HANAOKA et al.
Appl. No. 10/635,915
March 24, 2005

AMENDMENTS TO THE DRAWINGS

REMARKS/ARGUMENTS

FIG. 3

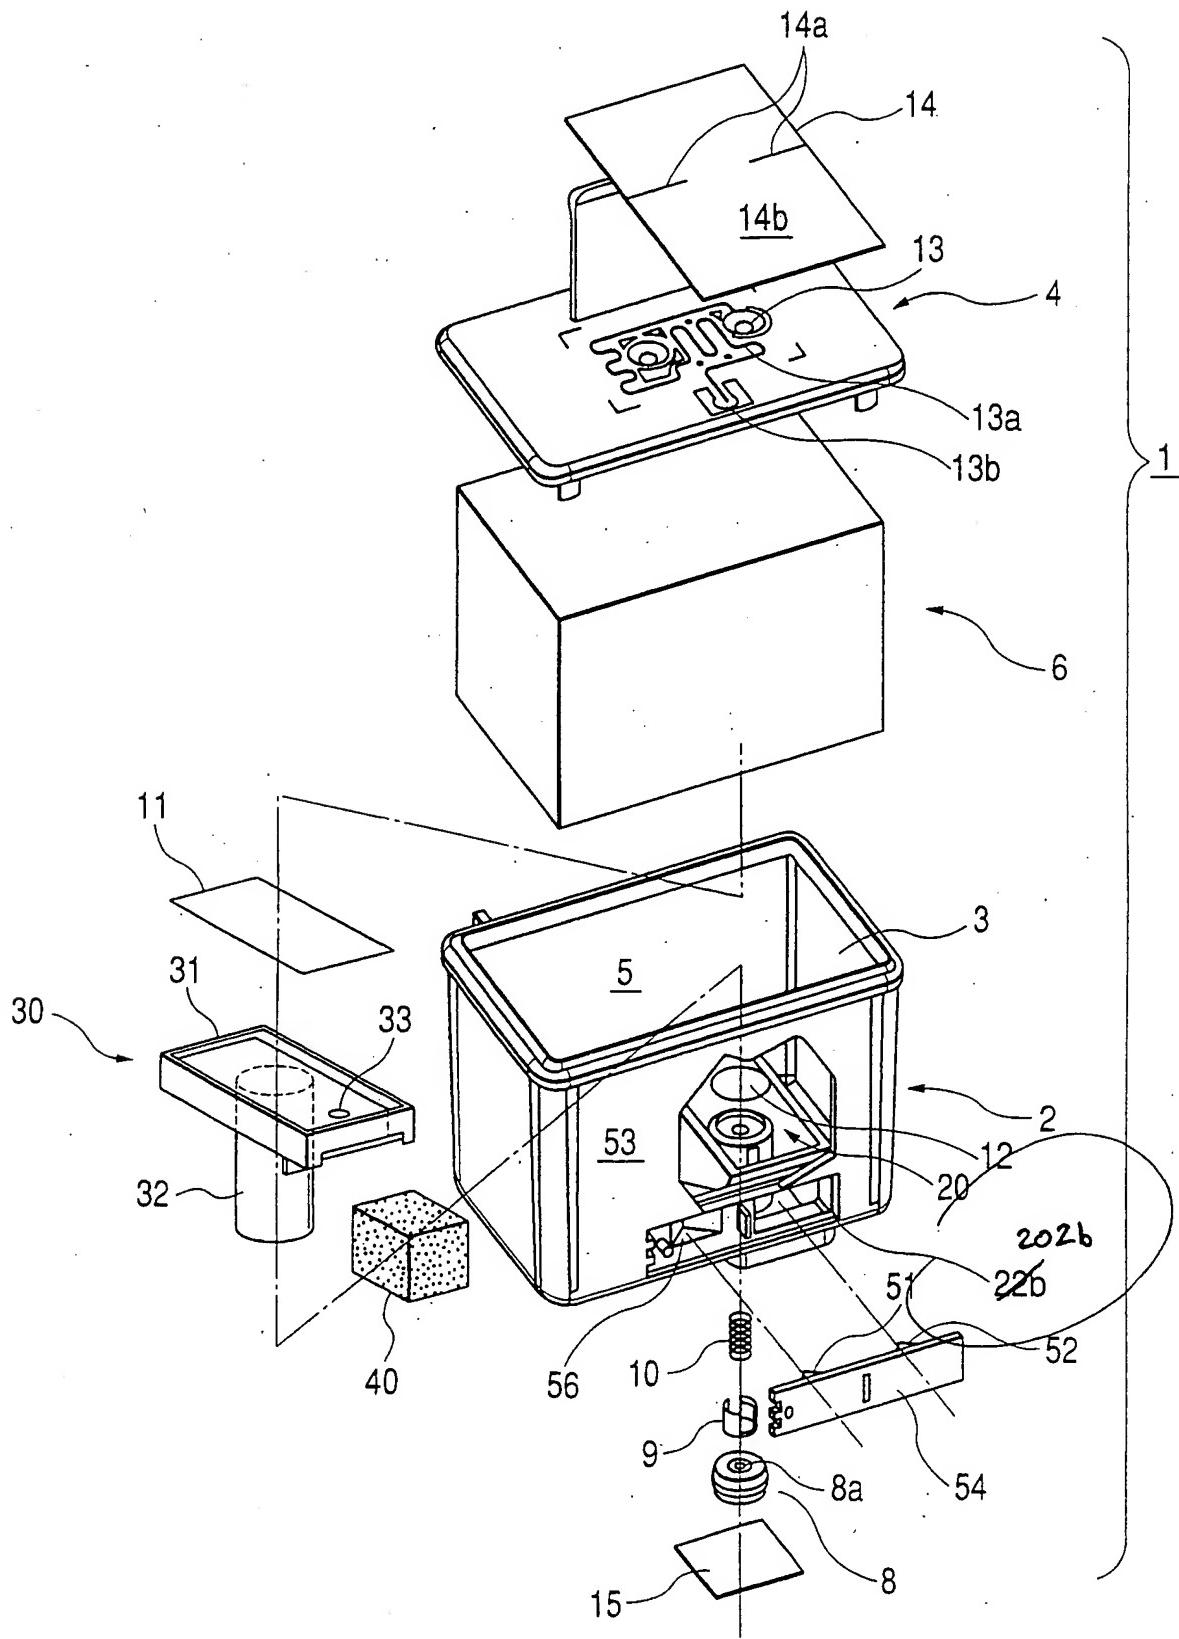
In paragraphs 1 and 2 of the Office Action, the drawings were objected to for lacking reference signs mentioned in the description and for including reference characters not mentioned in the description. Corrected drawing sheets and replacement sheets are attached hereto. Withdrawal of the objections is respectfully requested.

Please amend the drawings as noted on the corrected drawing sheets attached. Also attached are replacement drawing sheets including all of the figures appearing on the immediate prior version of the sheet. The replacement sheets are labeled "Replacement Sheet" in the page header.
